**DEFENSE NUCLEAR FACILITIES
SAFETY BOARD**

February 19, 2016

Summary of the Underground Ventilation System Project and Related Observations

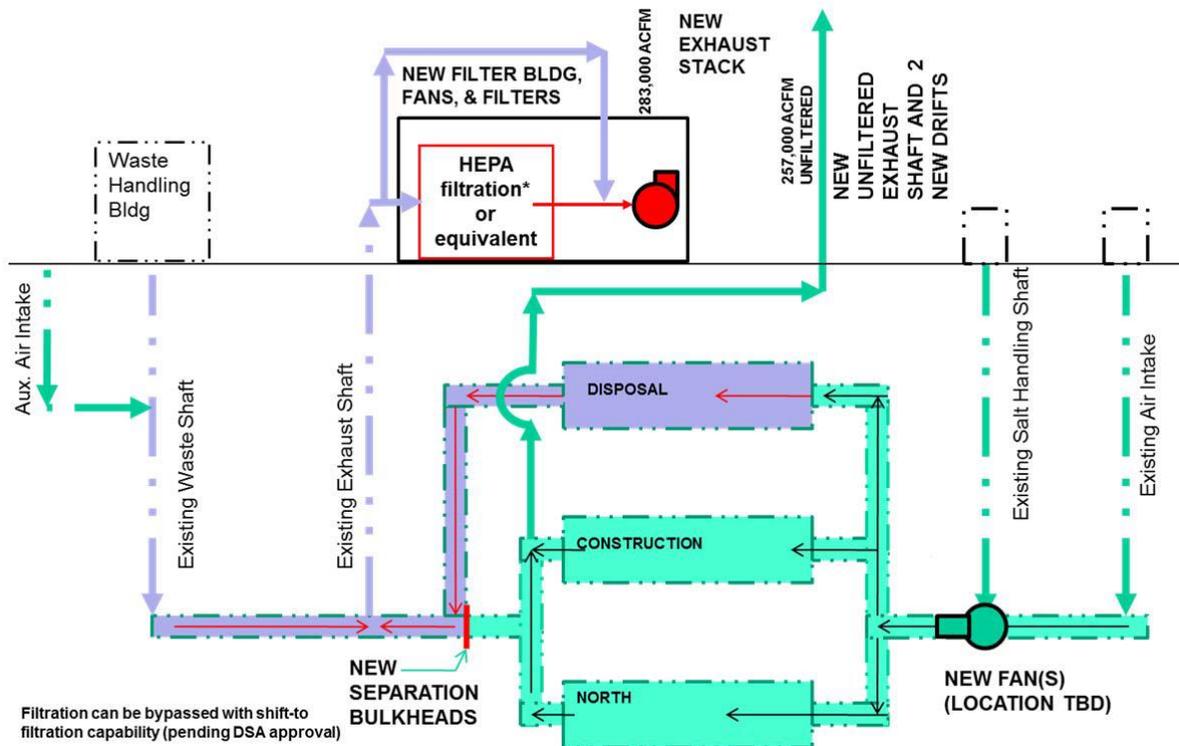
between zones would preferentially flow into the potentially contaminated zone that provides HEPA filtration of the air before exhausting it to the environment. As will be discussed in further detail below, this configuration allows for a bypass of the HEPA filters. Exhaust from the potentially contaminated zone will be redirected from the bypass through the HEPA filters when detected airborne contamination exceeds a yet to be determined threshold.

Confinement Strategy Observations—The Board’s review team identified a concern regarding potential reliability issues of the bypass switch to confinement capability on the detection of airborne radioactive material in the potentially contaminated zone. The CSDR identifies the potential for re-suspension of contaminated salts in the existing exhaust shaft and

- Qualifying and testing bypass isolation dampers that would be integral to directing flow to the HEPA filters in the event of an airborne release of radioactive contaminants in the underground. The effectiveness of the HEPA filters could be diminished if the high dust and salt content in the exhaust air compromise the sealing capability of the bypass dampers.

Project personnel confirmed that meeting the necessary functional and performance requirements commensurate with safety significant structures, systems, and components (SSCs) related to the bypass function will be further evaluated early in the preliminary design phase of the project. Based on the challenging environmental conditions and past performance of the WIPP CAMs and dampers, the Board's staff believes that testing and qualification of these systems to determine if they can meet their safety functions when called upon might require a technology readiness assessment prior to upcoming CD milestones. DOE currently requires that technology readiness level 7 be achieved at CD-2. The next major milestone is a combined CD-2/3 in fiscal year 2017. If the bypass function is found to be infeasible, project personnel indicated that waste disposal operations will be subject to full-time active confinement ventilation.
